Access Compliance Report Public Rights-of-Way (Curb Ramps)

Main Street: BASKERVILLE_RD		Cross Street: KITTRICK_DR		Location:	E
ADA ID: RPAT211202090943	Ramp Type:Type 1 - Perpendicular Diagonal Initial Pass/Fail: Fail		Overall Compliance: No	Severity Score:	15
Codes/Mitigation Info/Possible Solution			Field Measurements/Component Compliance

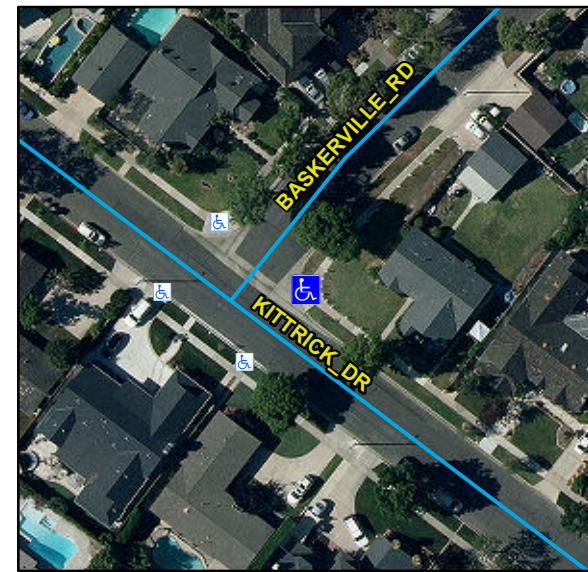
Compliance	Description	Data	Compliance	Description	Data
N/A	Ramp Length (in)	82	N/A	Flare Type LT	
Yes	Ramp Width (in)	48			N/A
No	Ramp Run Slope (%)	9.3	N/A	Flare Slope LT (%)	N/A
Yes	Ramp Cross Slope (%)	1.2	N/A	Flare Traversable LT	N/A
N/A	Landing Present	N/A	N/A	Flare Type RT	
N/A	Landing Length (in)	N/A			N/A
N/A	Landing Width (in)	N/A	N/A	Flare Slope RT (%)	N/A
N/A	Landing Run Slope (%)	N/A	N/A	Flare Traversable RT	N/A
N/A	Landing Cross Slope (%)	N/A	N/A	DWS Provided	N/A
N/A	Landing Movement Obstructed?	N/A	N/A	DWS Contrast	N/A
	Landing Movement Type	N/A	N/A	DWS Length (in)	N/A
N/A	Landing Shared	N/A	N/A	DWS Full Width	N/A
N/A	Clear Space	Yes	N/A	DWS Offset Left (in)	N/A
N/A	Clear Space To Crosswalk (in)	N/A	N/A	DWS Offset Right (in)	N/A
N/A	Marked Crosswalk 1	No	N/A	Marked Crosswalk 2	No
	Crossing 1 Direction	NW		Crossing 2 Direction	SW
	Marked Crosswalk 1 Width (in)	N/A		Marked Crosswalk 2 Width (in)	N/A

Remove & Replace Curb Ramp With Two New Directional Ramps or Equivalent.
